Stage 1 Road Safety Audit

Gort Town Centre Public Realm Scheme

On behalf of **Galway County Council**

3.2.2 Pedestrian Connectivity Lowry's Lane to Town Core

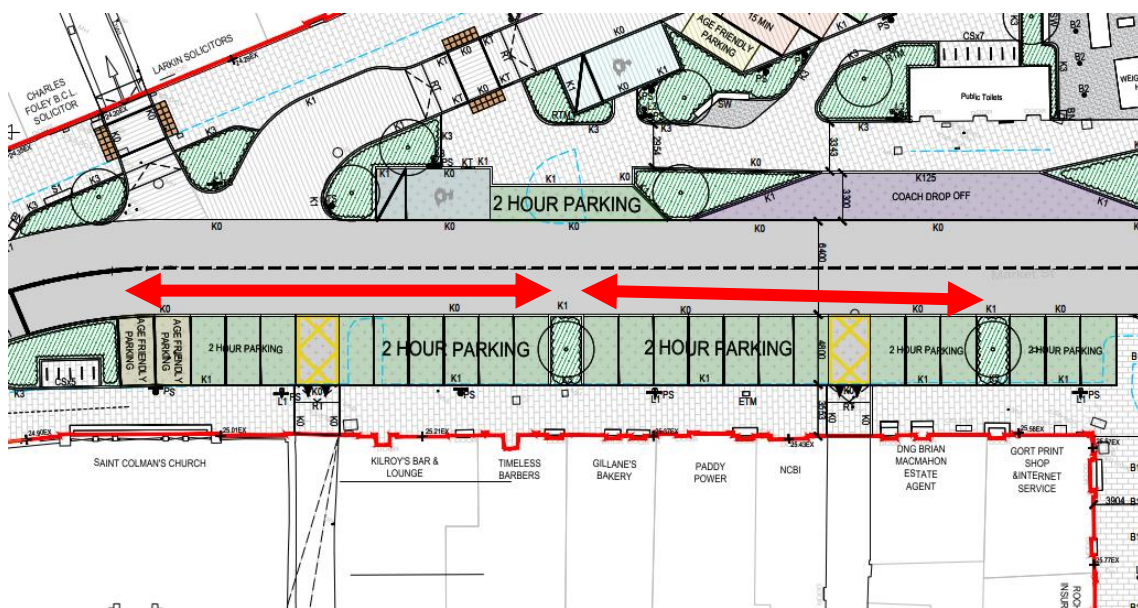
Problem: There is a large car park proposed for Lowry's Lane. The likely desire line for pedestrians from this car park is to walk along Lowry's Lane into Market Street and across to the town core. The pedestrian crossings of Market Street are to both ends, which requires a diversion off the likely desire line. Pedestrians are likely to cross Market Street as a continuation of, or close to, Lowry's Lane.

Hazard: No assistance for sight impaired pedestrians attempting to cross the road in this location is given. The sight impaired pedestrian may errantly enter the carriageway, into the path of oncoming traffic.

Recommendation: The Design Team should provide an uncontrolled crossing closer to the likely pedestrian desire line.

3.2.2	Yes	No	We will provide a raised crossing as a shared space to enable access to the main square and traffic calming along Market Street	Yes
3.2.3	Yes	Yes

3.2.4 Vehicular Footpath Crossovers

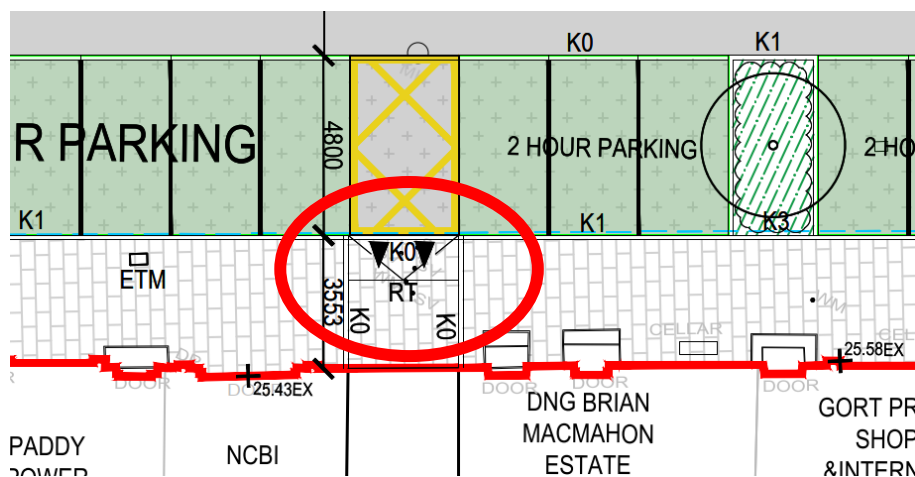
Problem: There are a number of locations where vehicles are permitted to cross the footpath in order to access driveways and back lands. At these locations a flush kerb is indicated to the rear of the car parking bay adjacent to a 100mm face kerb. It appears there is a ramp up from the car park level to the footpath level incorporated into the footpath. There are two problems with this arrangement.

1. Pedestrians walking along the line of the footpath may trip on the side of the ramp.
2. Sight impaired users may errantly depart the footpath where there is zero kerb face and walk within the car parking bays / carriageway.

Recommendation: Omit any trip hazards within the footpath and also retain a minimum 60mm kerb face between the footpath and the car parking bay / carriageway.

3.2.4	Yes	No	This is a tried and tested detail which allows a continuous footpath level for a minimum of 2m against the building edge and then a sloped section for cars to mount. This detail ensures that there are not excessive slopes across the whole footpath and towards the channel line of the road. The paving will also be contrasting colour to demarcate this as a driveway crossover.	Yes

3.2.5 Driveway Visibility

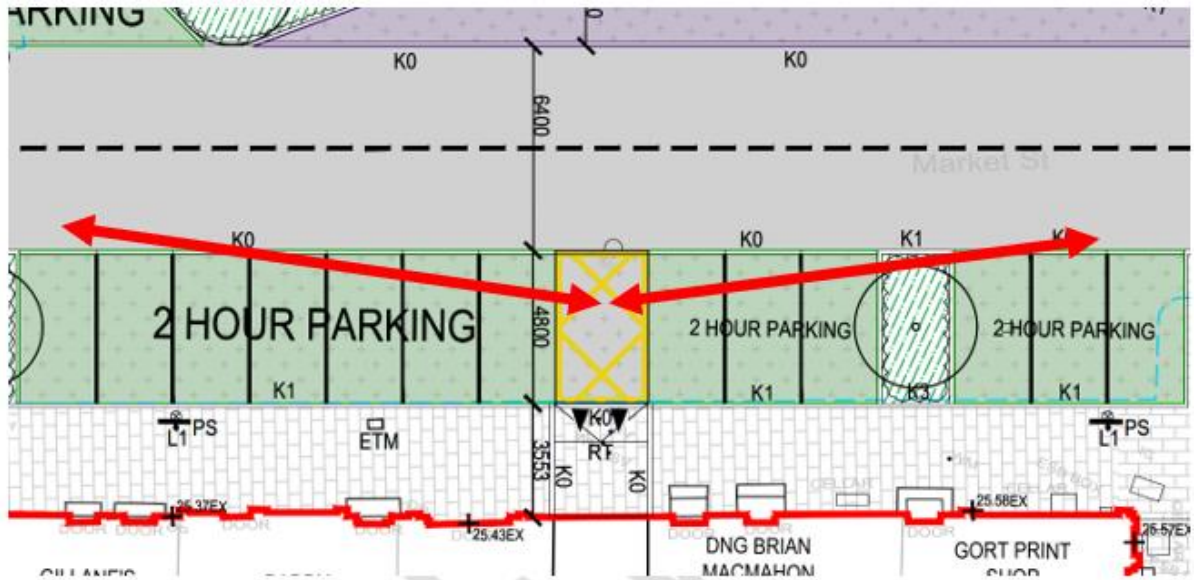
Problem: There are a number of locations where vehicles are permitted to cross the footpath in order to access driveways and back lands in between roadside parking bays. Visibility may be restricted by high sided vehicles in the parking bay.

Hazard: Motorists may proceed into the path of oncoming traffic.

Recommendation: Ensure adequate visibility is provided for all users entering the public carriageway.

3.2.5	Yes	No	This is typical and an existing scenario within the town where there is on street parking and entrances to driveways / alleyways. Its not feasible to take out all of the parking on the streets, instead the yellow markings provide a clear space for vehicles to enter an exit. There is very low number of vehicles doing this movement.	Yes. However, it is suggested the landscaping within the bay is located to the approaching traffic side of the entrance, to provide some visibility.

3.2.6 Pedestrian Crossings – Visibility

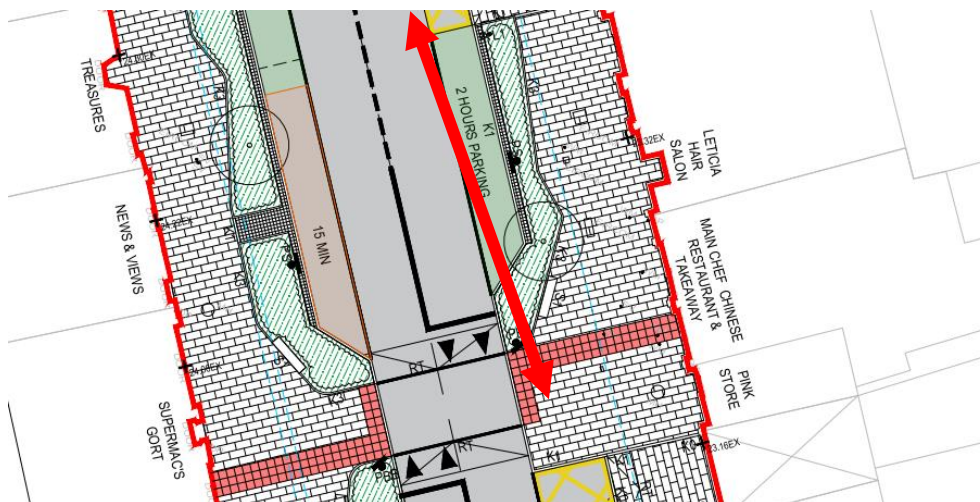
Problem: Visibility to pedestrians waiting to cross the road may be restricted by high sided vehicles parked in adjacent parking bays and/or high vegetation. This problem includes signal-controlled crossing locations, as pedestrians often cross the carriageway even when shown a red man at the light.

Hazard: Pedestrian may step out into the path of oncoming traffic.

Recommendation: the Design Team should ensure adequate visibility is provided. This should include pedestrians waiting to the rear of push chairs at the carriageway edge.

3.2.6	No	Yes	Across the town we have designed lots of crossings with a set back before the parking spaces are created. The crossing in this case is raised to further calm traffic and the crossing is built out the channel line to maximise visibility. All planting next to crossings will be maintained to a maximum 600mm high

3.2.7 Sharp Kerb Edges

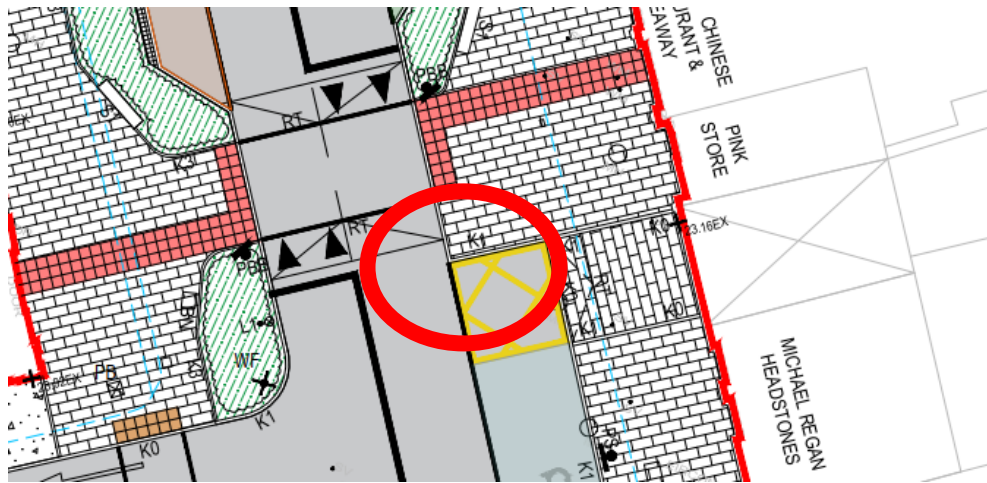
Problem: There are areas within the design that indicate a 100mm high kerb meeting at a 90 degree corner. Vehicles that attempt to turn at these locations are at risk of tyre damage on the kerb.

Hazard: Tyre damage caused at these locations may result in tyre failure elsewhere on high-speed roads.

Recommendation: The Design Team should design out areas of potential vehicle tyre damage.

3.2.7	No	Yes	All 90 degree kerbs will be a smooth radius quadrant kerb with a bull nose top	
3.2.8	Yes	Yes		
3.2.9	Yes	No	A paved margin will be provided adjacent to the kerb to assist connectivity for all vehicle passengers	Yes

3.2.8 Disabled User Parking Bays – Church Street and Market Street

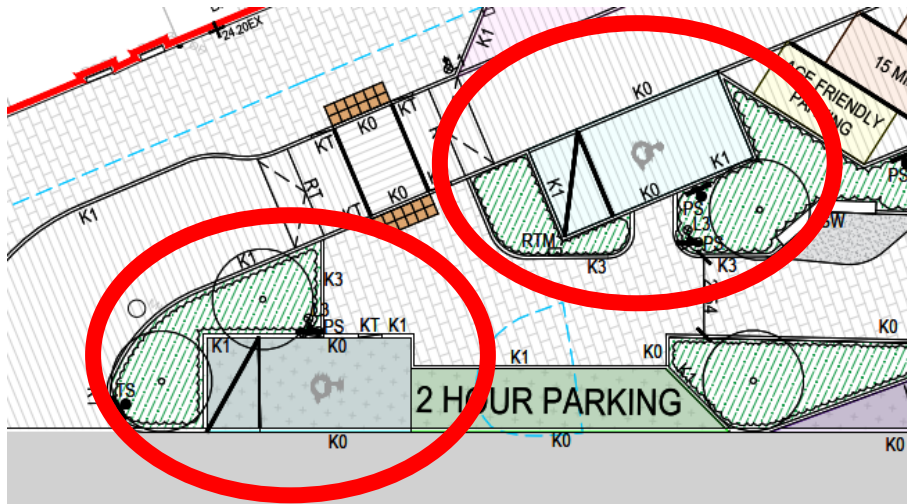
Problem: There are a number of disabled user parking bays located throughout the scheme. Some of these bays have landscaping located between the bay and the footpath. Users with differing disabilities use different methods of accessing / egressing their vehicles. This can include rear door access, rear side doors or front doors.

Hazard: Disabled users without direct access to the footpath may be required to travel on the carriageway prior to accessing the footpath. Impact from passing vehicles may result.

Recommendation: The Design Team should ensure direct access to the footpath can be achieved from all the vehicle passenger doors.

3.2.9 Landscaping Adjacent to Parking Bays

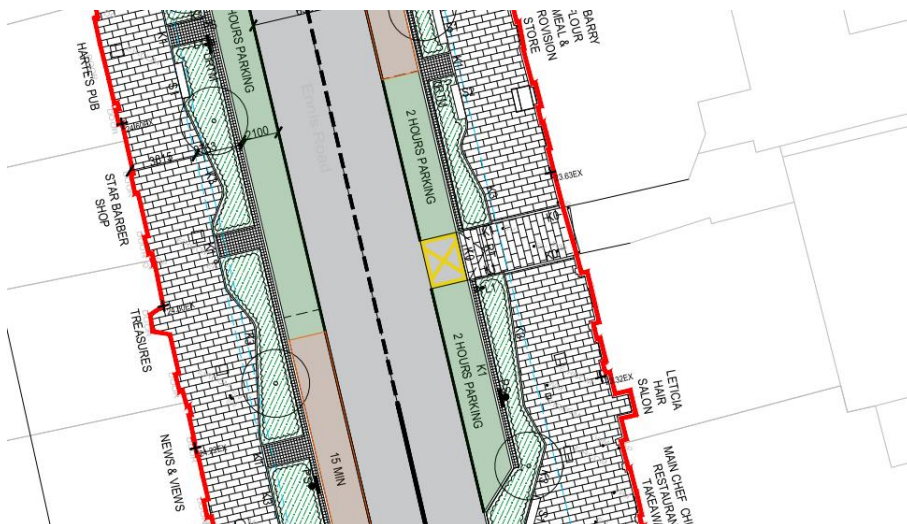
Problem: There are lengths of linear landscaping strips located adjacent to on-line parking bays. Although there are a number of paved links from the footpath at the rear of the landscaping through to the parking bay, these links will only be of use if the parked vehicle directly aligns with the paved link and even then, they will only be of use for the passenger adjacent to this link.

Hazard: Vehicle drivers and passengers are likely to walk within the carriageway until they can find a paved link through to the footpath. This may involve walking the full length of the parking bay on the carriageway. Impact from passing traffic may result.

Recommendation: The Design Team should omit the landscaping and provide direct connectivity to the footpath for all vehicle passengers.

3.2.10 Coach Drop-off Bay

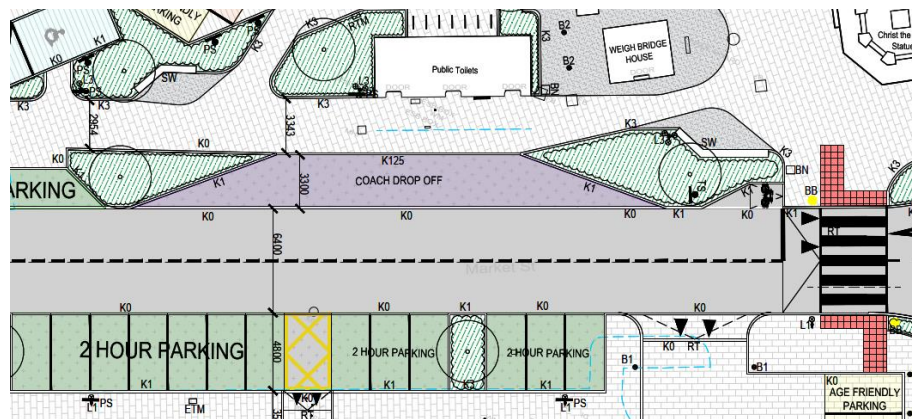
Problem: The coach drop-off bay is located on the northern side of Church Street. No information has been provided by the Design Team to the route of the coach. There is concern the coach may arrive from the M18/R458. If this is the case the coach will need to turn on or near to Church Street in order for the passenger door to be adjacent to the footpath, or passengers will alight into the carriageway. There is no obvious location for the coach to undertake a 'U' turn along Church Street.

Hazard: The coach may attempt to reverse into one of the side streets off Church Street. Impact with other road users may result. If passengers alight into the carriageway, impact from passing traffic may result.

Recommendation: The Design Team should ensure the coach arrives from Church Street west and does not need to undertake a 'U' turn in order to achieve a drop off or collection.

3.2.10	No	Yes	The coach will have a set route and will not turn in side streets	
3.2.11	Yes	Yes		
3.3.1	Yes	No	Options are being considered to provide necessary vehicular access to Lowrys Lane from the new off street car park, to omit the need for vehicles to use this link	No. The outcome of these "considerations" may be to maintain vehicu- lar use of the link.

3.2.11 Church Street – Perpendicular Parking Bays

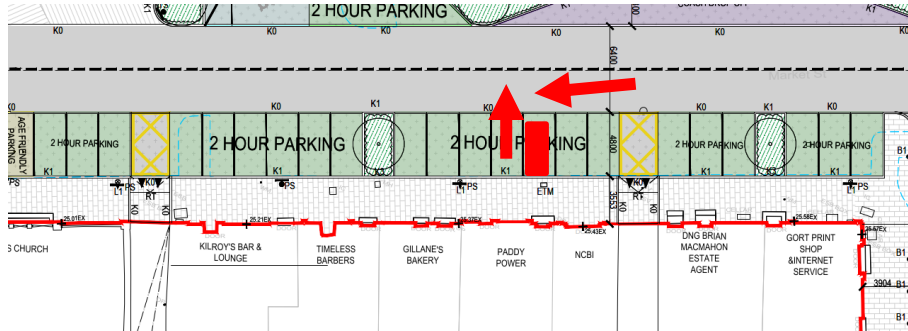
Problem: There is a long run of perpendicular parking bays on Church Street. Users attempting to exit these bays may have visibility to oncoming traffic restricted by adjacent parked high-sided vehicles.

Hazard: Exiting motorists may be struck by passing mainline traffic.

Recommendation: The Design Team should provide a buffer strip between the carriageway and parking bay, such that mainline traffic can observe a moving vehicle and slow/stop to permit this vehicle safe egress.

3.3.1 Crowe Street Car Park – Pedestrian Access

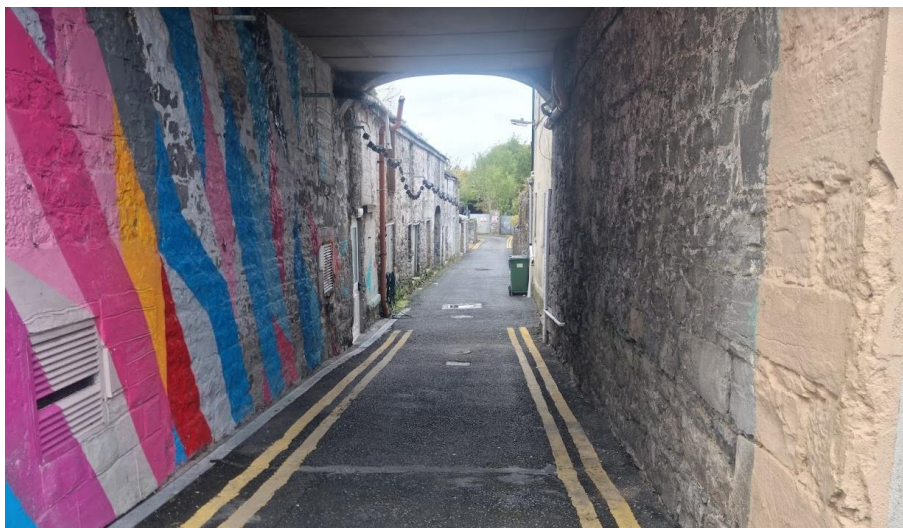
Problem: It appears from the drawings that pedestrian access to/from the car park is intended to be achieved via Lowry's Lane. This lane is very narrow and currently used by vehicles to access the rear of premises.

Hazard: Motor vehicles are unlikely to have sufficient room to pass wheelchair users. The motorist may decide to reverse back onto Market Street. Impact with pedestrians on Market Street may result.

Recommendation: Prohibit vehicular use of the lane.

3.3.2 Lowry's Lane – Pedestrian Access

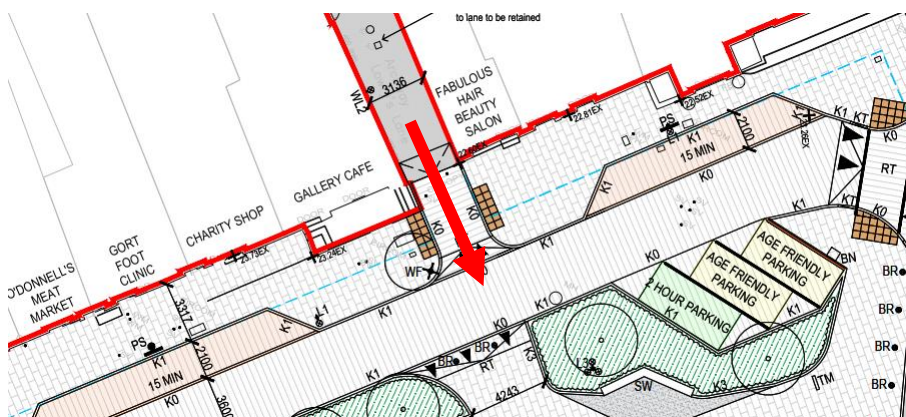
Problem: Pedestrians walking from Crowe Street car park to the town core are likely to walk along Lowry's Lane. Upon arrival at Market Street the pedestrian, possibly sight-impaired, is offered no warning they may be entering the Market Street carriageway.

Hazard: Motor vehicle impact with pedestrians on Market Street may result.

Recommendation: The Design Team should provide a pedestrian deterrent / hazard warning surface at the junction of Lowry's Lane / Market Street.

3.3.3 Crowe Street Car Park – Visibility

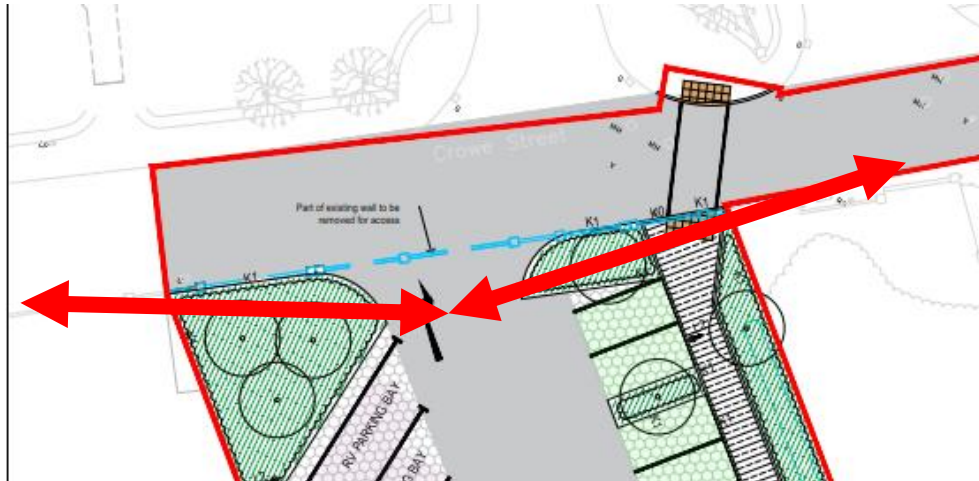
Problem: Visibility on exit from the car park may be restricted in either direction by boundary walls / vegetation.

Hazard: Car park users may exit into the path of oncoming traffic.

Recommendation: The Design Team should ensure suitable visibility is provided in both directions.

3.3.4 Crowe Street Car Park – RV Parking

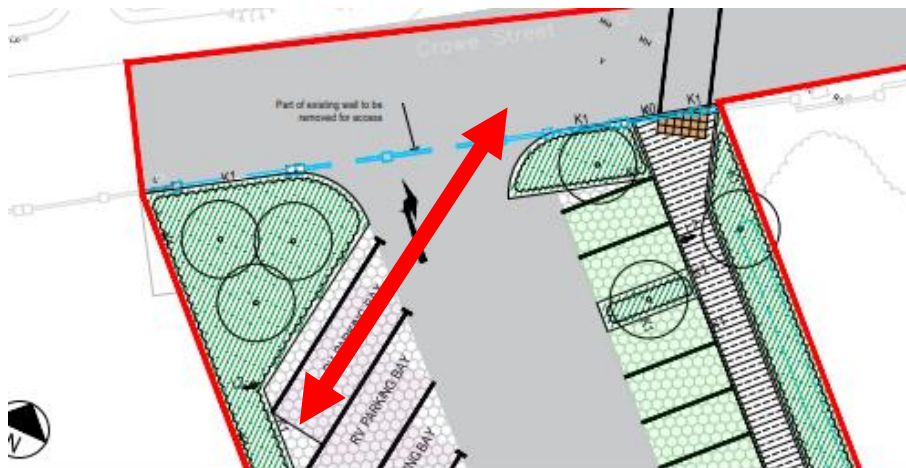
Problem: RV parking is indicated near the entrance to the car park. It is not clear how long vehicles are meant to enter / exit these spaces. It is likely the users will drive forward into the space and reverse back out of the car park junction in order to exit.

Hazard: Impact with vehicles entering the car park may result.

Recommendation: The RV spaces should be relocated where entry and exit to the car park can be achieved without need to reverse towards entering vehicles.

3.3.6 Crowe Street – Widening (2)

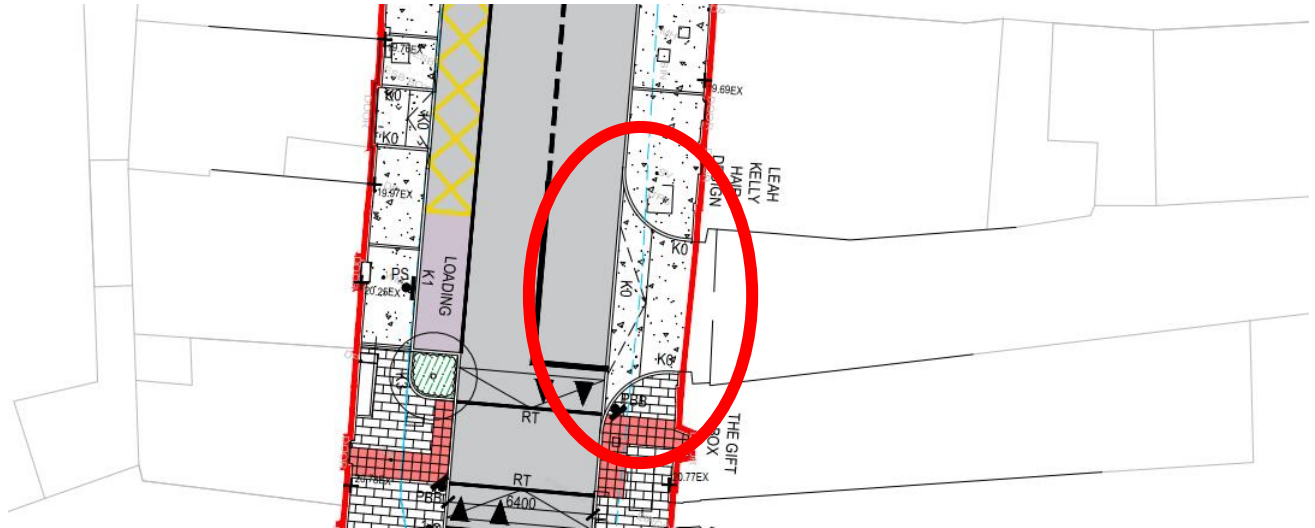
Problem: Two separate sections of carriageway widening are proposed on Crowe Street for passing of opposing vehicles. There is concern the widenings will be used for vehicle parking and serve to further reduce the available carriageway width.

Hazard: Head-on impacts from opposing vehicles may result.

Recommendation: The Design Team should ensure the passing bays are kept clear of parking vehicles.

3.3.9 Church Street – Zebra Crossing near Garraghbeg Road

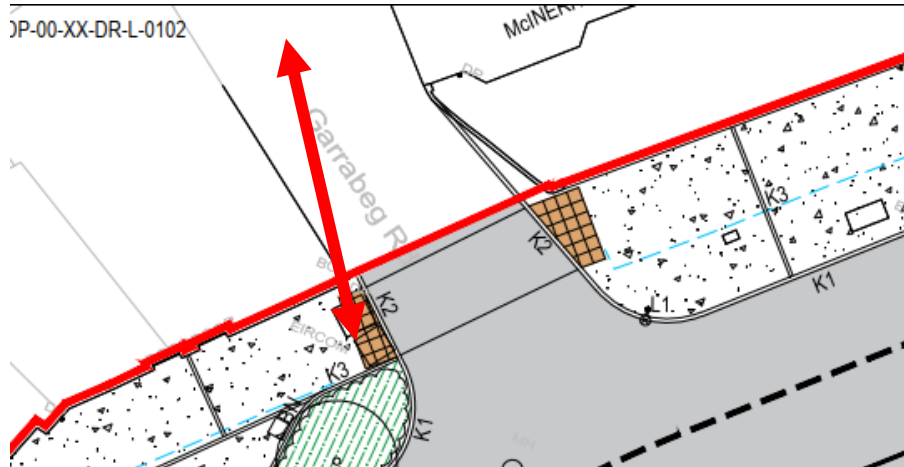
Problem: There is a zebra crossing proposed to the south of Garraghbeg Road junction. This zebra crossing is located on a bend with both landscaping and vehicles parking to both sides. Pedestrians waiting to cross the road may be shielded from view by either/or the landscaping or parked high sided vehicles.

Hazard: Pedestrians may commence their crossing into the path of unsighted vehicles.

Recommendation: The Design Team should ensure all visibility splays are clear of obstruction.

3.3.2	Yes	Yes		
3.3.3	Yes	Yes		
3.3.4	Yes	Yes		
3.3.5	Yes	Yes		
3.3.6	Yes	Yes		
3.3.7	Yes	Yes		
3.3.8	Yes	Yes		
3.3.9	No	Yes	We have carefully located the crossing at this location to ensure the best possible vis- ibility given the bend in the road. In addition this crossing is a raised table. All vegetation will be ground cover to ensure visibility

3.3.11 Church Street – McNerney Auctioneers and Dwelling House

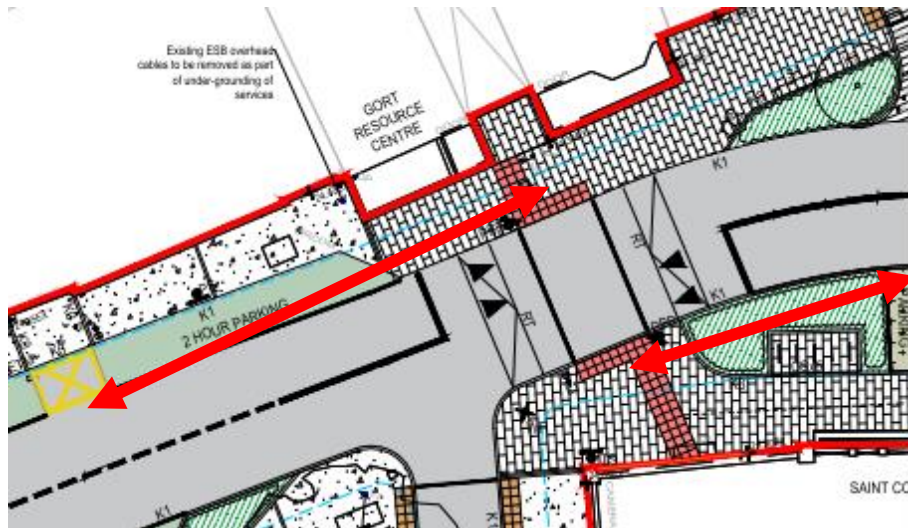
Problem: There is existing off-street parking located at McNerney Auctioneers and a dwelling house at the corner of the Gort Family Practice. The proposals include for the provision of a 100mm high kerb across both entrances and also a parking bay.

Hazard: Riders of powered two-wheeled vehicles may lose vehicle control when attempting to cross the kerb. Additionally high sided vehicles in the parking bay may restrict visibility on exit from the driveways.

Recommendation: The Design Team should provide suitable entrance to the parking areas, with suitable visibility splays.
